SURRY POWER STATION, UNIT NO. 1

AMENDMENT TO FACILITY OPERATING LICENSE

Amendment No. 97
License No. DPR-32

ATTACHMENT TO LICENSE AMENDMENT

TS Figure 5.1-1

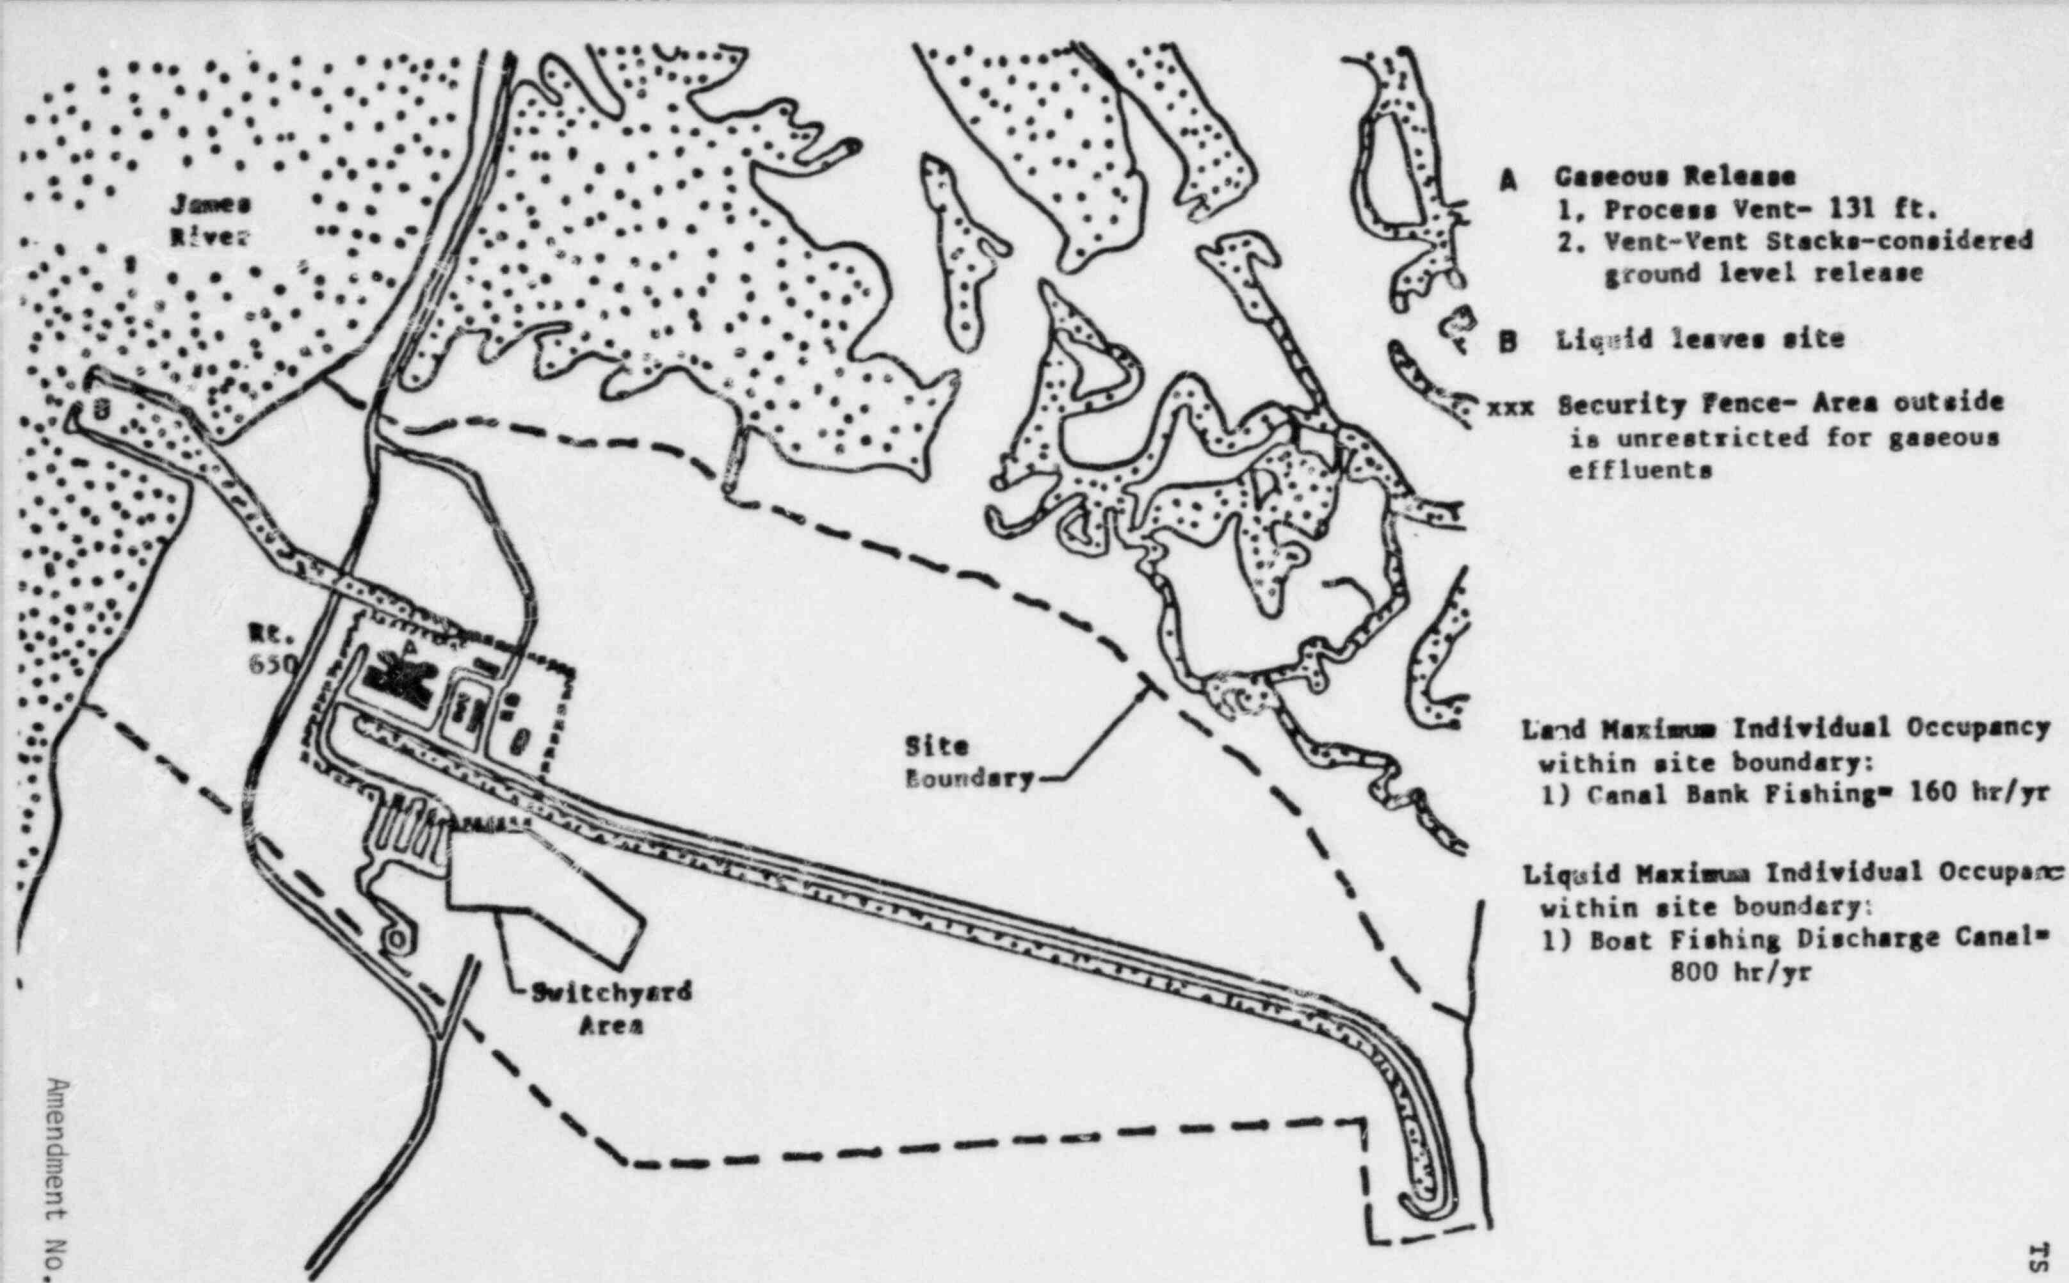
- a. The concentration of radioactive material released in liquid effluents to unrestricted areas (see figure 5.1-1) shall be limited to the concentrations specified in 10 CFR Part 20, Appendix B, Table II, Column 2, for radionuclides other than dissolved or entrained noble gases. For dissolved or entrained noble gases, the concentration shall be limited to 2×10^{-4} microcuries/ml.
- b. With the concentration of radioactive material released in liquid effluents to unrestricted areas exceeding the above limits, without delay restore the concentration to within the above limits.

The Surry Power Station is located in Surry County, Virginia, on property owned by Virginia Electric and Power Company on a point of land called Gravel Neck which juts into the James River. It is approximately 46 miles SE of Richmond, Virginia, 17 miles NW of Newport News, Virginia, and 25 miles NW of Norfolk, Virginia. The minimum distance from a reactor centerline to the site exclusion boundary as defined in 10CFR100 is 1,650 ft. This is the distance for Unit 1, which is controlling. A map of the site is shown in TS Figure 5.1-1.
